The authors sincerely appreciate your valuable comments and suggestions to help improve the manuscript. We have revised the manuscript titled “Estimating the Snow Density using Collocated Parsivel and MRR Measurements: A Preliminary Study from ICE-POP 2017/2018”. that was submitted to ACP (Atmospheric Chemistry and Physics) on 3 January, 2024. Based on your suggestions, we have put substantial effort into additional analysis. The manuscript has been thoughtfully revised regarding the comments from all reviewers.

Figure R1: (a) The retrieved bulk density as a function of MRR reflectivity. (b) Same as (a), but for bulk water fraction.

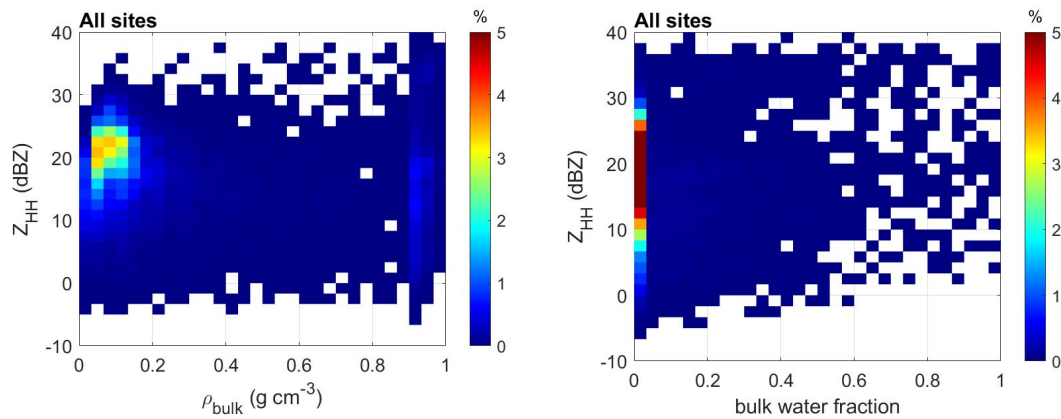
Do the authors see a possibility that the retrieved high values of bulk density and liquid fraction during periods of low reflectivity and precipitation rate could be, at least partly, an artifact from applying the method on observations of very weak precipitation? The retrieval seems somewhat unstable in these conditions which is not surprising considering factors such as low signal to noise ratio due to weak signal. Yet, the authors draw considerable attention to the retrievals of these periods of very weak precipitation. It is worth considering which disciplines would benefit from the microphysical retrievals of weak mixed phase precipitation (<0.5mm/h)? I would suggest either introducing a threshold for minimum reflectivity or precipitation rate where the method is applied, or otherwise critically reviewing the method's performance in weak precipitation, where the precipitation rate falls below the sensitivity of the Pluvios.

Reply: The retrieved bulk density and bulk water fraction as a function of density are shown in Figure R1. Most retrieved bulk density is obtained from MRR reflectivity from 10 to 30 dBZ. Some retrieval results with high bulk density and low MRR reflectivity can be found, but not frequent.

The quality of the retrieval results has been greatly improved by applying the post-processed MRR data as per the reviewer's suggestion. The low SNR MRR measurement has been removed. The authors intend to preserve as much data as possible by only eliminating the data with an attenuation effect on MRR reflectivity. The attenuated MRR reflectivity underestimates the retrieved bulk density and bulk water fraction.

Figure R2: (a) The retrieved bulk density from collocated MRR and Parsivel. The blue dots are retrieved from CF-adjusted PSD. The red dots are from the original PSD. The gray dots are the retrieval from PIP. The case is 28 February 2018. (b) Same as (a), but for case 7 March 2018.

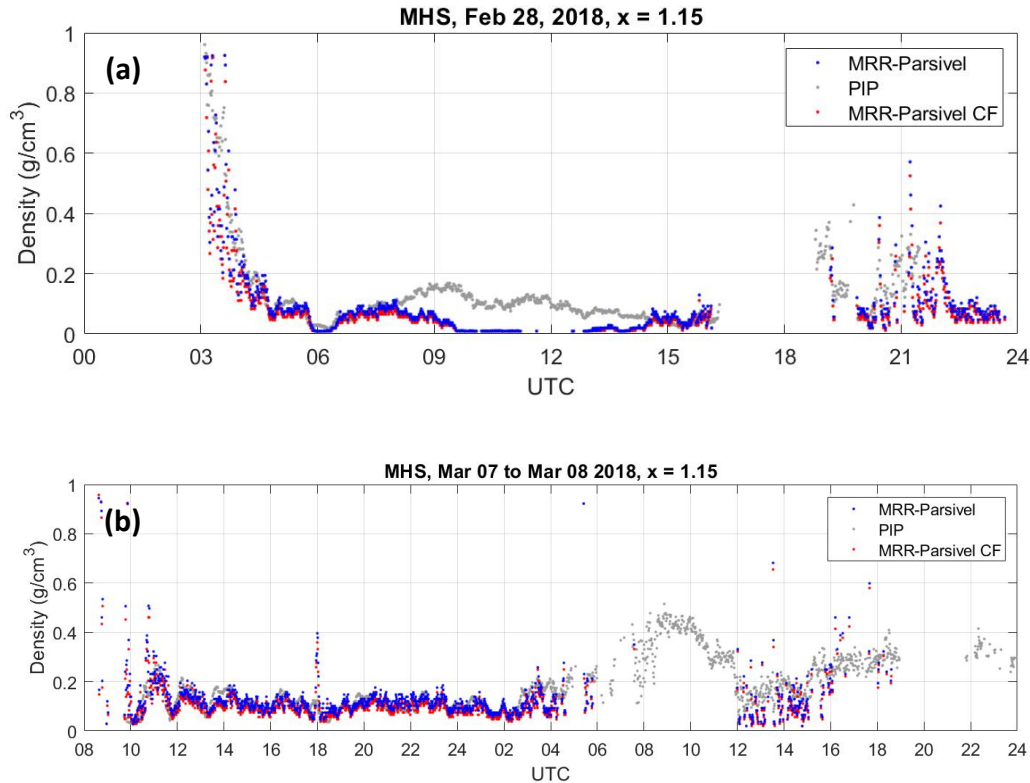
I don't feel that the retrieval of v_w is adequately demonstrated in the case studies since there seem to be no time periods where there would be both a) agreement between derived and measured terminal velocity and b) notable precipitation intensity at the same time. It raises the concern how the method would perform in mixed phase situations with larger particles or higher precipitation rates. In my mind, the best way to address this would be to replace one of the case studies with another one that has significant intensity of wet snow, or discuss the possible limitations of the method's application.

Reply: The bulk water fraction is derived along with the maximum possible bulk density using the proposed method in this study. If a different assumption is made when selecting possible bulk density, the retrieved bulk water fraction will be different. Therefore, the performance of the retrieved bulk water fraction is linked with bulk density retrieval. Since there are no direct measurements of bulk water fraction, we will compare the retrieved bulk density from the proposed method and PIP. The consistency between retrieved bulk density from the two algorithms confirms that the retrieved bulk water should be reasonable.

As shown in Fig. R2(a), the retrieved bulk density values from the proposed algorithm and PIP gradually decrease from nearly 1.0 to 0.1 ($g\ cm^{-3}$) between 03 and 06 UTC. Both algorithms capture the transition from the mixing-phase to dry snow. Please see Figure R2. The manuscript has been revised to include a discussion of bulk water fraction retrieval. Please see Line 398-417.

Figure R1: (a) The retrieved bulk density from collocated MRR and Parsivel. The blue dots are retrieved from CF-adjusted PSD. The red dots are from the original PSD. The gray dots are the retrieval from PIP. The case is 28 February 2018. (b) Same as (a), but for case 7 March 2018.

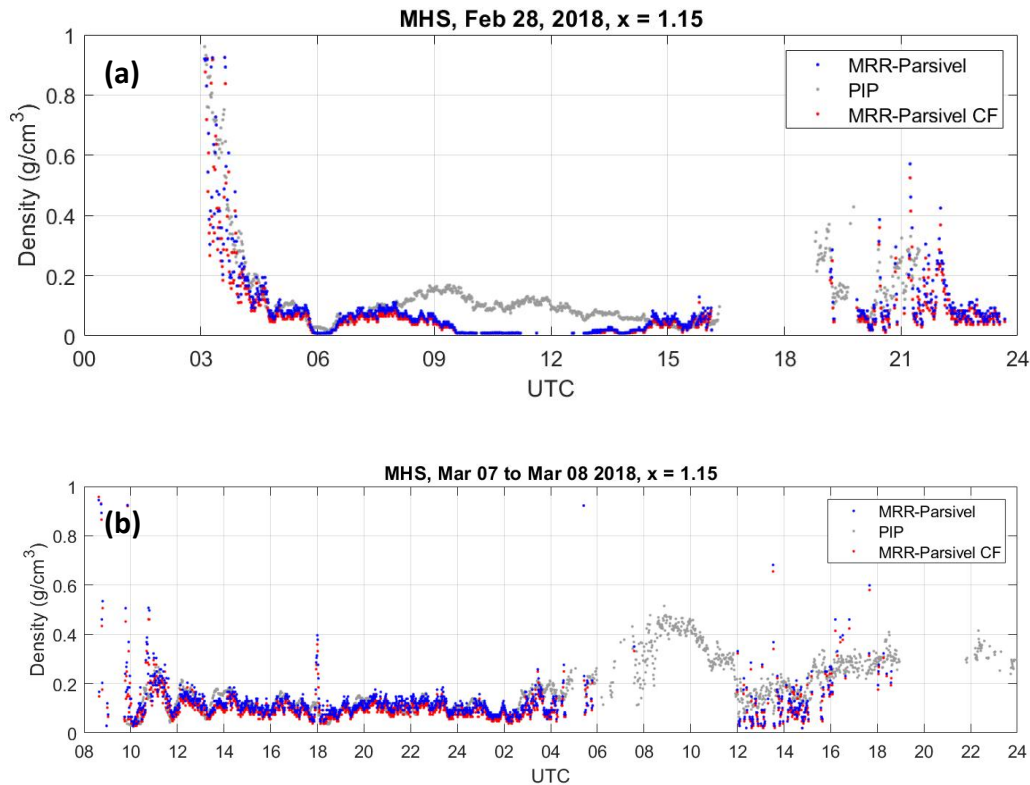
L149-153: This part of the methodology also requires more complete explanation and evidence. I'm not sure I follow and agree with your argument here.

Reply: The bulk water fraction is derived along with the maximum possible bulk density in the proposed method in this study. If different assumption is made in the selection of possible bulk density, the retrieved bulk water fraction will be different. Therefore, the performance of the retrieved bulk water fraction is linked with bulk density retrieval. Since there are no direct measurements of bulk water fraction, we will compare the retrieved bulk density from the proposed method and PIP. The consistency between retrieved bulk density from two algorithm confirms that the retrieved bulk water should be reasonable. Please see Figure R1.

As shown in Fig. R1(a), the retrieved bulk density values from the proposed algorithm and PIP gradually decrease from nearly 1.0 to 0.1 (g cm^{-3}) between 03 and 06 UTC. Both algorithms capture the transition from the mixing-phase to dry snow. Please see Figure R1 in the previous reply. The manuscript has been revised to include the discussion of the bulk water fraction retrieval. Please see Line 398-413.

Figure R2: The number concentration distribution measured of reflectivity from MRR and simulated reflectivity from Parsivel of BKC site. The bias is -2.1 dBZ, and the standard deviation is 1.28 dBZ.

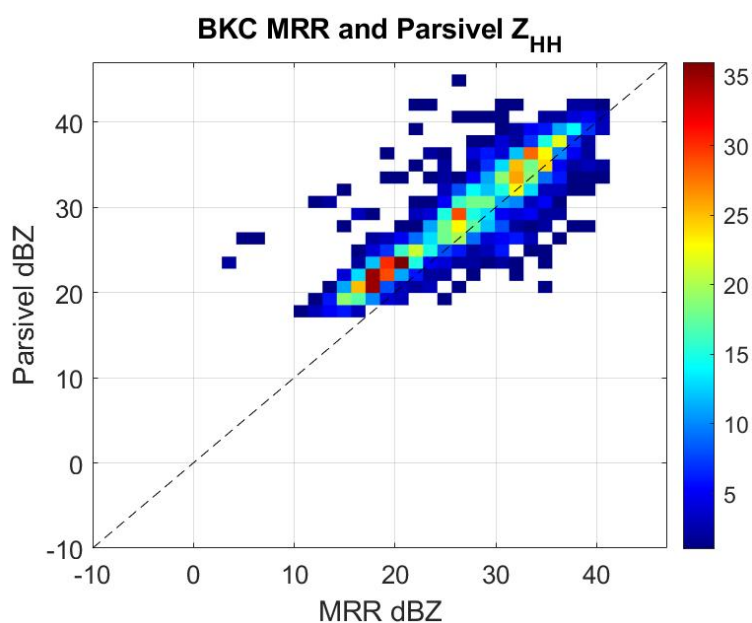
L104-106: "Bias" already implies that an average was taken, no need to say "mean bias". What are the standard deviations of the differences between the MRR Z_{HH} and the simulated Z_{HH} ? This would provide some insight into the uncertainty of the bias estimates.

Reply: The “mean bias” has been revised to “bias” per the reviewer’s suggestion. The number concentration plot of MRR measured reflectivity, and Parsivel PSD calculated reflectivity, as shown below in Figure R2. The standard deviation of the differences between them is about 1.1 to 1.3 dB for each site (shown in Table 2 of the revised manuscript). As the reviewer indicates that the standard deviation value can be considered as the MRR reflectivity uncertainty. The standard deviation will be further applied to investigate the bulk density retrieval uncertainty.
